Title - Sujet Replacement of Sewage Lift Station	
Solicitation No. - N° de l'invitation F1700-150830/A	Amendment No. - N° modif. 001
Client Reference No. - N° de référence du client F1700-150830	Date 2016-02-29
GETS Reference No. - N° de référence de SEAG PW-\$PWY-028-7747	
File No. - N° de dossier PWY-5-38386 (028)	CCC No./N° CCC - FMS No./N° VME
Solicitation Closes - L'invitation prend fin at - à 02:00 PM on - le 2016-03-02	
Time Zone Fuseau horaire Pacific Standard Time PST	
F.O.B. - F.A.B. Plant-Usine: <input type="checkbox"/> Destination: <input checked="" type="checkbox"/> Other-Autre: <input type="checkbox"/>	
Address Enquiries to: - Adresser toutes questions à: Lam (PWY), Tian	Buyer Id - Id de l'acheteur pwy028
Telephone No. - N° de téléphone (604) 775-9382 ()	FAX No. - N° de FAX (604) 775-6633
Destination - of Goods, Services, and Construction: Destination - des biens, services et construction: DFO - Institute of Ocean Sciences - Sidney, BC

Replacement of Sewage Lift Station Addendum #1

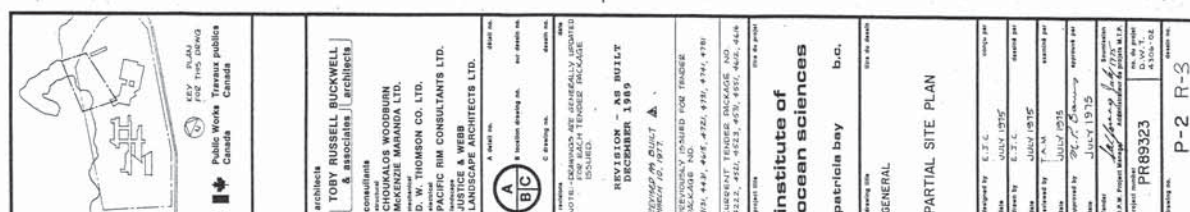
1. **Flow rate and head conditions for the pump station:** existing pumps are rated at 360USGPM and cycle roughly 7 times per day.
2. **Size of line feeding the pump station:** see attached drawing.
3. **Suction point for pump:** see attached drawing.
4. **Discharge point:** easiest to use the existing discharge line from the drywell.
5. **How long would the bypass need to run:** Until new system is fully operational.
